YORK STREET INTERCHANGE – DRAFT ORDERS AND ENVIRONMENTAL STATEMENT

YORK STREET INTERCHANGE – DRAFT ORDERS AND ENVIRONMENTAL STATEMENT: FOLLOW UP

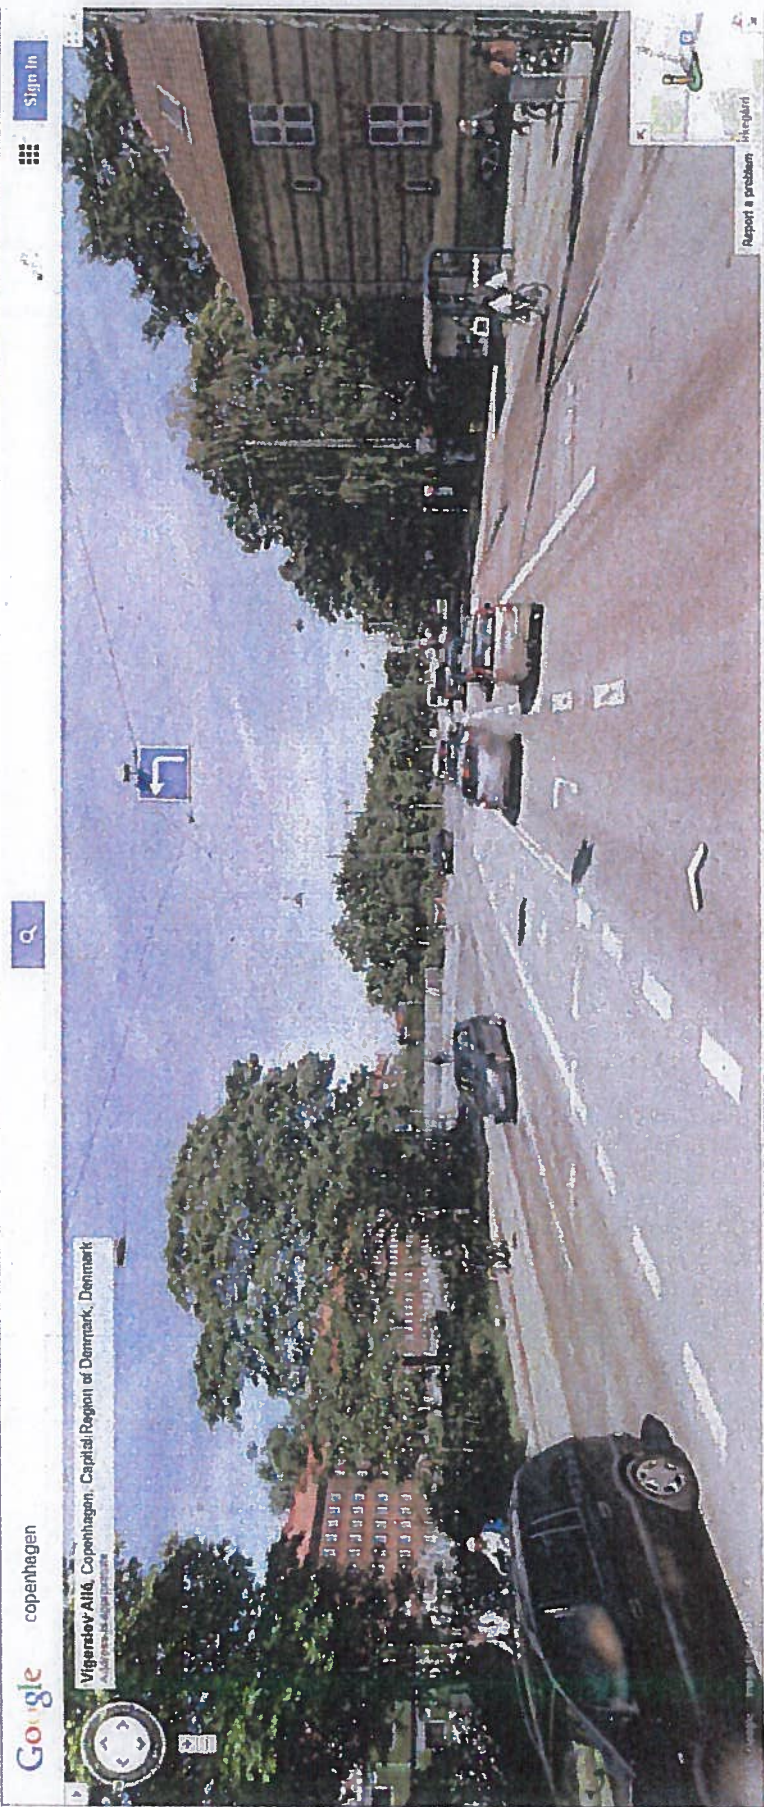
Cycling Unit would therefore recommend 2.0m segregated cycling lanes in each direction throughout York Street (i.e. from Frederick Street / Great Patrick Street to Brougham Street / Dock Street) in the form of a stepped 'Copenhagen' style lane (I have attached a graphic).

I believe there is sufficient width within the remits of the scheme if buffer strips can be reduced to 0.6m and the bus lane from 3.5m to 3.2m.

I have also attached an example of how stepped lanes carry cycling provision through junctions in Copenhagen.
